# Briefing paper: Viva Energy gas terminal emissions significantly underreported

28 February 2022

## Comparison of greenhouse gas assessments in Environment Effects Statements (EES) for Viva Energy's Geelong gas terminal vs AGL's Westernport terminal reveals true scope of climate impact.

Figure 11-2 shows the boundary with transport fuel emissions in scope, labelled 'LNG Carrier':

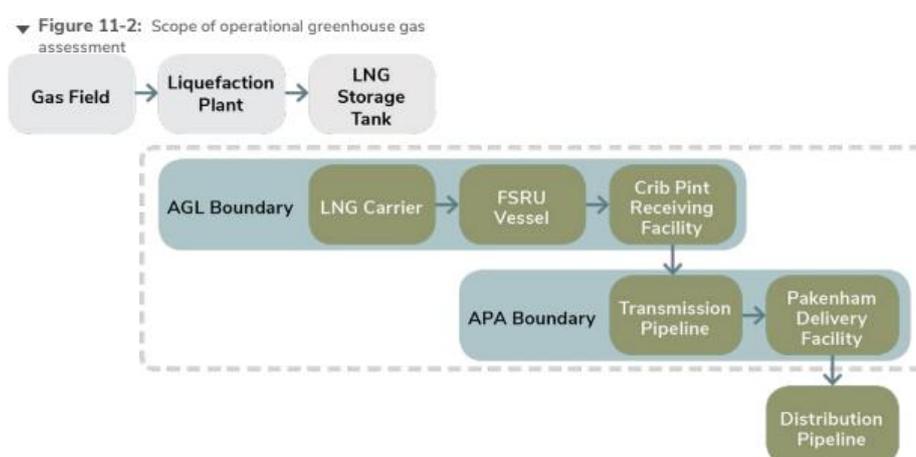
AGL's EES document further clarifies that transport is included:

Key Scope 3 emissions that were included in the assessment include:

- transportation of liquefied natural gas (LNG) to Crib Point Jetty by the LNG carriers
- transport of workers to the Project site
- embodied emissions in steel and concrete used in construction.

Figure 9-3 Operation phase emissions sources within the project's operational boundary

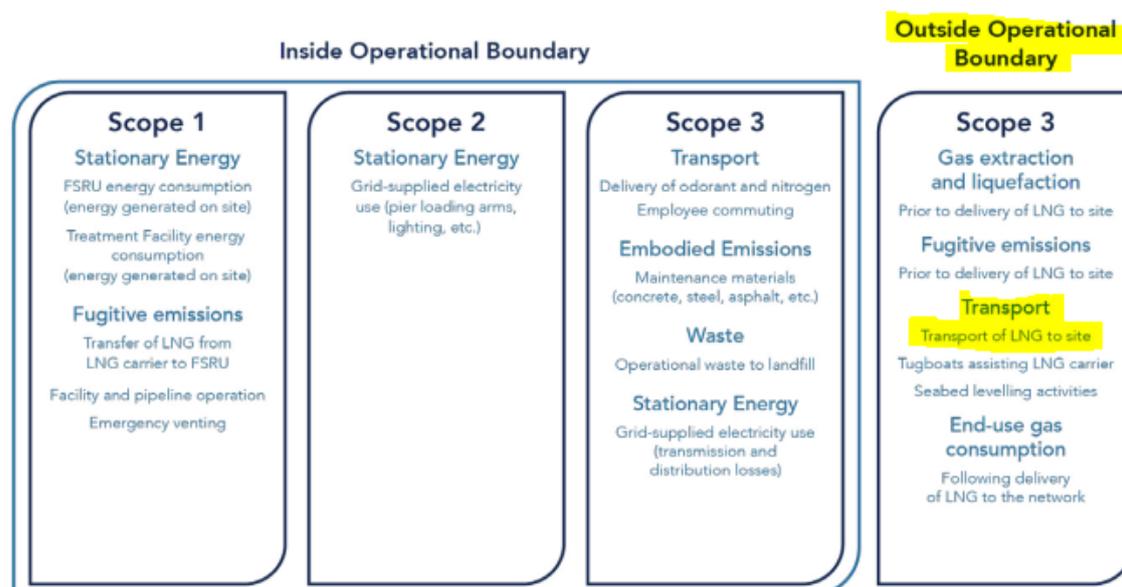
But unlike AGL, Viva Energy has deemed LNG transport to Geelong as sitting outside their Scope 3 emissions, despite this being the largest source of GHG emissions through the whole value chain.

As a consequence, Viva Energy estimates that the total annual operations emissions (Scope 1, Scope 2, and ‘relevant’ Scope 3) of its FSRU operating in open loop mode would amount to just **47,906 tonnes of CO<sub>2</sub>-e**, approximately nine times less than the figure reported by AGL. This is despite both

Viva Energy's EES justifies excluding emissions from transporting the LNG as follows: "The decisions around the sourcing of LNG cargoes would be made by the customers of the terminal and not by Viva Energy as the operator, therefore the upstream emissions associated with transport of the LNG to the terminal were also not included in the study." (Viva Energy EES, Chapter 9, 9-6)

The study scope section 9-2 clarifies that the emissions boundary is limited to activities that are within Viva Energy's "ability to control".

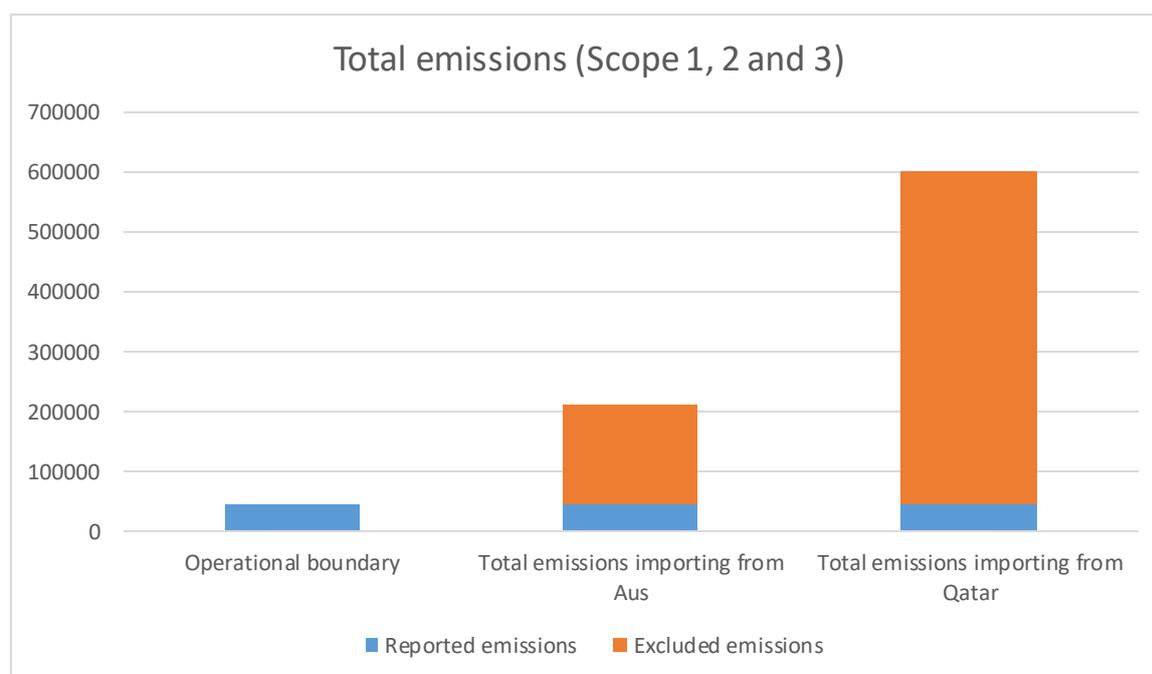
While Viva Energy tried to exclude transport fuel emissions from their operation boundaries in the main text of the EES, the company did provide some figures in its *Technical Report C Greenhouse Gas Assessment*<sup>7</sup>, Appendix A Scope 3 emissions outside of the operational boundary.

This document shows fuel transport emissions ranging from 165,500 tonnes of CO<sub>2</sub>-e if gas is sourced from Australia to 553,400 tonnes of CO<sub>2</sub>-e if gas were to be supplied from Qatar.<sup>8</sup>

If Viva Energy had followed the relevance test of the GHG Protocol, the internationally recognised authority in this space, the project's emissions would be 4 or 12 times higher than what Viva has recognised so far. This is a massive difference, and it is up to Viva to explain why it chose to exclude the biggest source of emissions from its greenhouse gas assessment, and only included it in the technical appendix of a 13,000 page EES document.
